SUBJECT: ISSUANCE OF AMENDMENT NO. 38 TO FACILITY OPERATING LICENSE NO. NPF-63  
REGARDING TECHNICAL SPECIFICATION CHANGE TO PRESSURE-TEMPERATURE  
LIMITS - SHEARON HARRIS NUCLEAR POWER PLANT, UNIT 1 (TAC NO. M85876)

AMENDMENT NO. 38 TO FACILITY OPERATING LICENSE NO. NPF-63 - HARRIS, UNIT 1

SAFETY EVALUATION BY THE OFFICE OF NUCLEAR REACTOR REGULATION  
RELATED TO AMENDMENT NO. 38 TO FACILITY OPERATING LICENSE NO. NPF-63

FIGURE 3.4-2

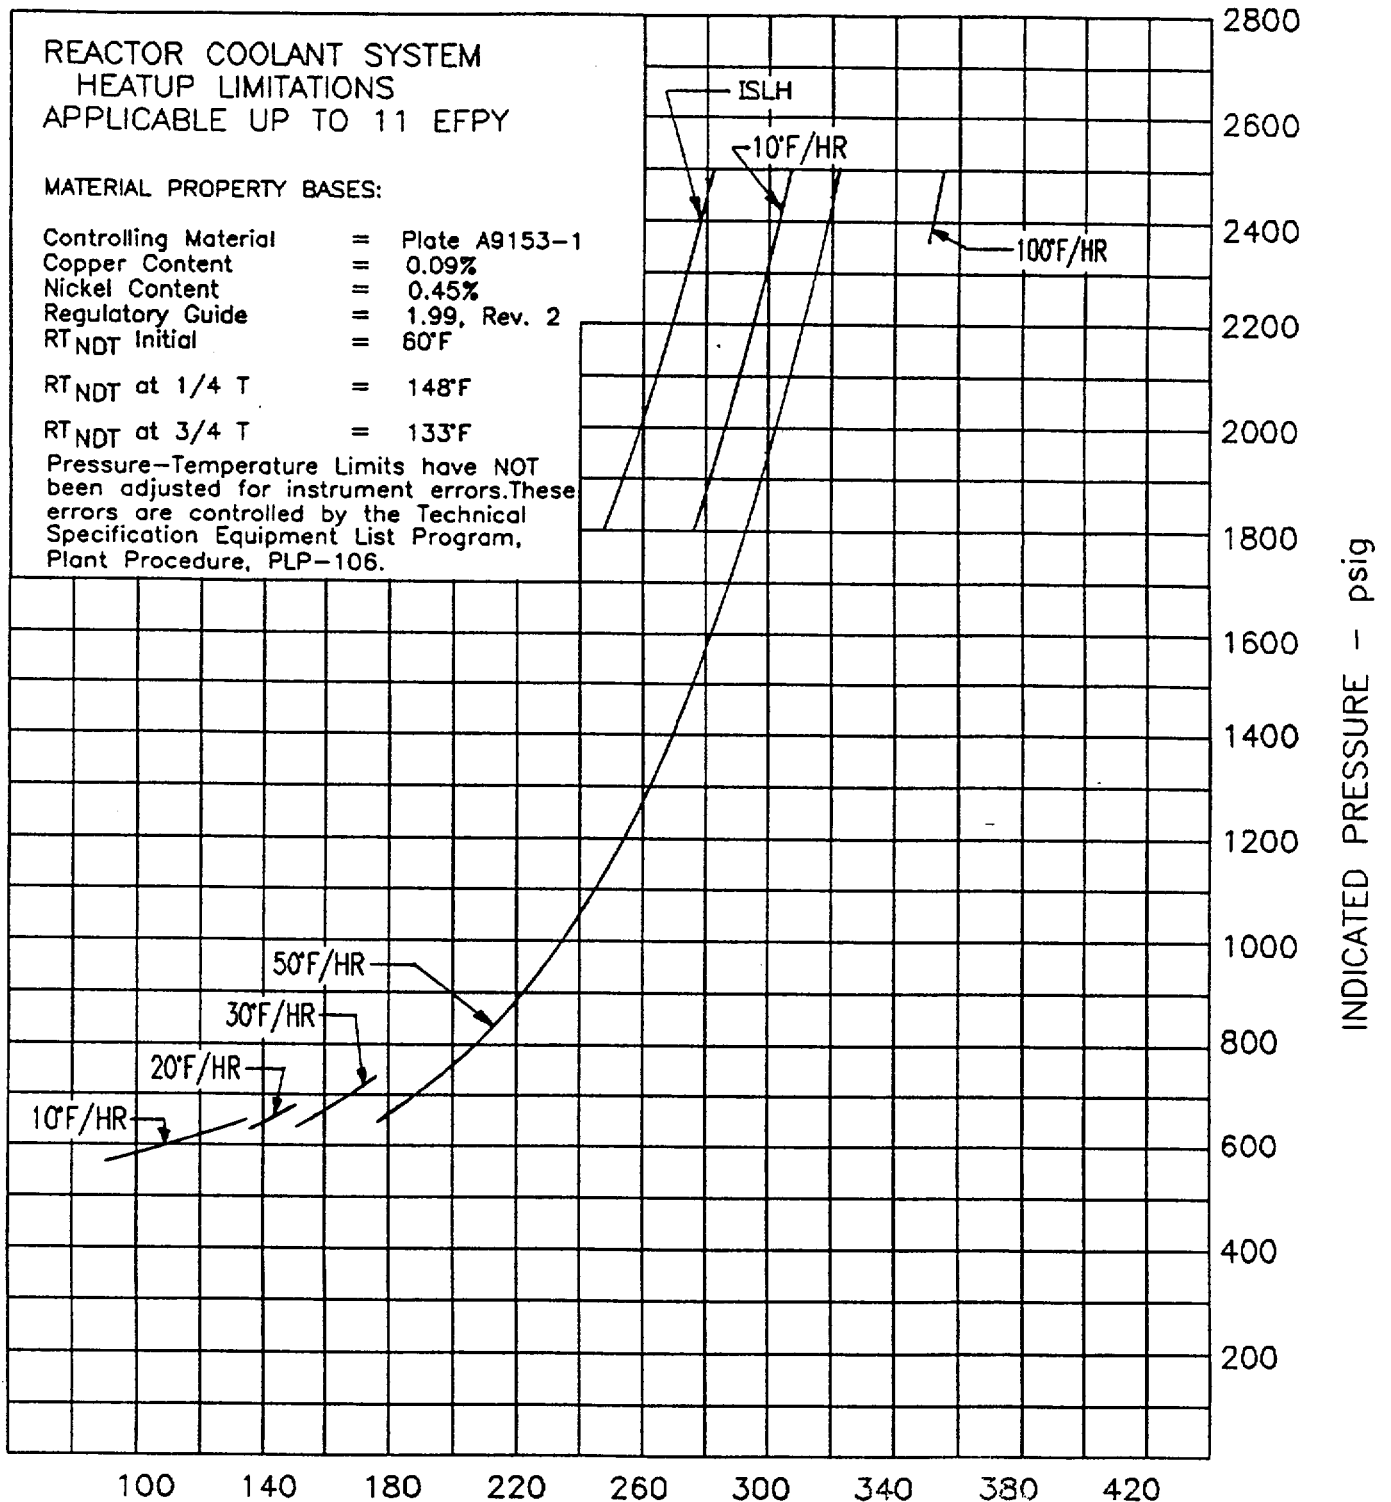
The amendment revises Technical Specifications 3/4.4.9, Pressure/Temperature Limits, by replacing the current 5 year heatup and cooldown limitations with revised limitations based on predicted reactor vessel neutron exposure at 11 effective full-power years of operation.

By letter dated February 26, 1993, as supplemented July 27, 1993, Carolina Power & Light Company (the licensee) requested a revision to Technical Specification (TS) 3/4.4.9 for the Shearon Harris Nuclear Power Plant (SHNPP). The revision to TS 3/4.4.9 would replace the current 5 year pressure-temperature limits with limitations through 11 effective full power years (EFPY) of operation.

REACTOR COOLANT SYSTEM  
COOLDOWN LIMITATIONS - APPLICABLE UP TO 11 EFPY

FIGURE 3.4-4

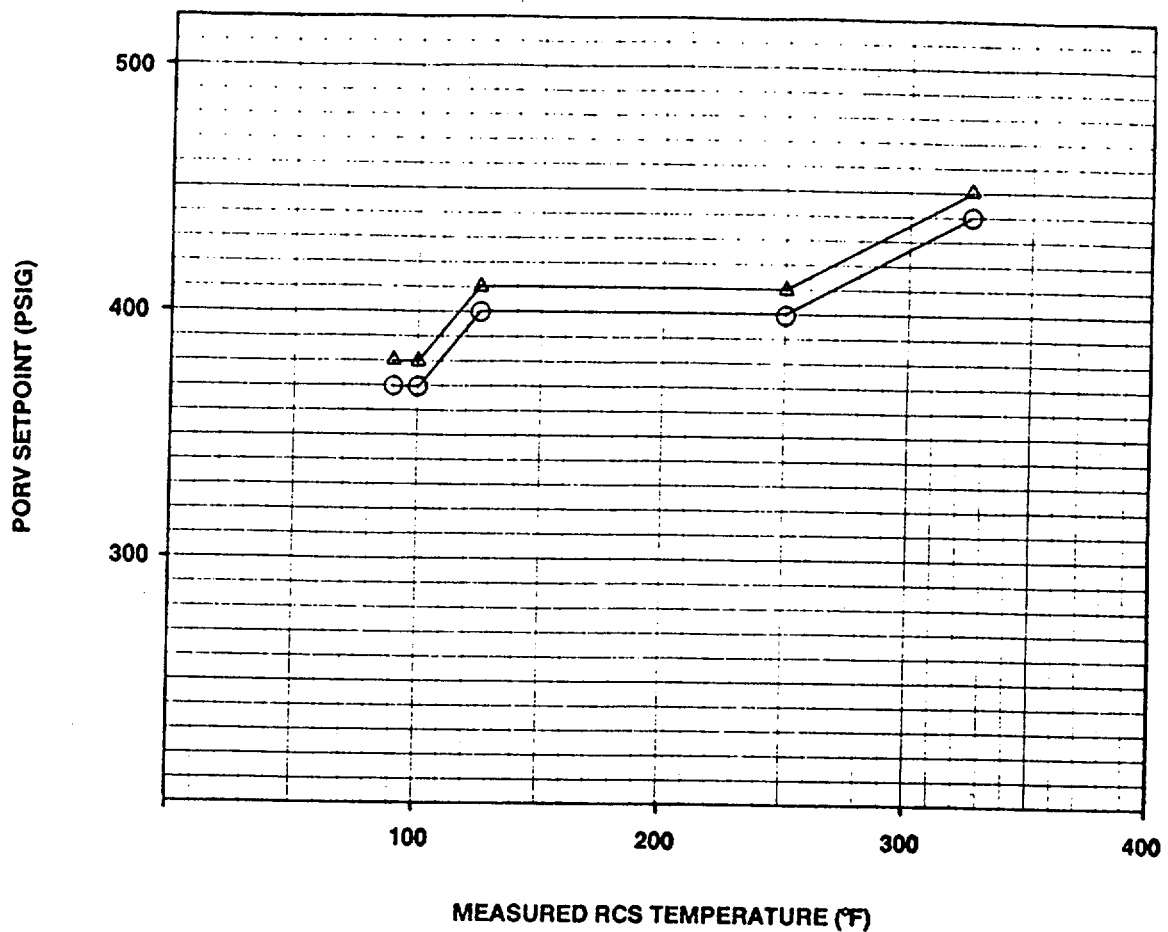
The combined effects of the less restrictive Appendix G limits, the decreased injection flow for the mass input event, the consideration of the dynamic pressure drop between the vessel beltline and pressure sensor location, and the increase in uncertainty in the pressure sensing instrumentation, have resulted in a net increase in pressure margin. This margin is variable over the temperature range of interest. To take advantage of this gain in pressure margin, the revised 10 CFR Part 50, Appendix G, pressure-temperature curves for the current heatup/cooldown rates have been shifted so each curve becomes effective at lower temperatures, and yet still can provide adequate margin.

RCS TEMP OF	LOW PORV * PSIG ○	HIGH PORV * PSIG Δ
90	370	380
100	370	380
125	400	410
250	400	410
300	427	437
325	440	450

\* VALUES BASED ON 11 EFPY REACTOR VESSEL DATA.
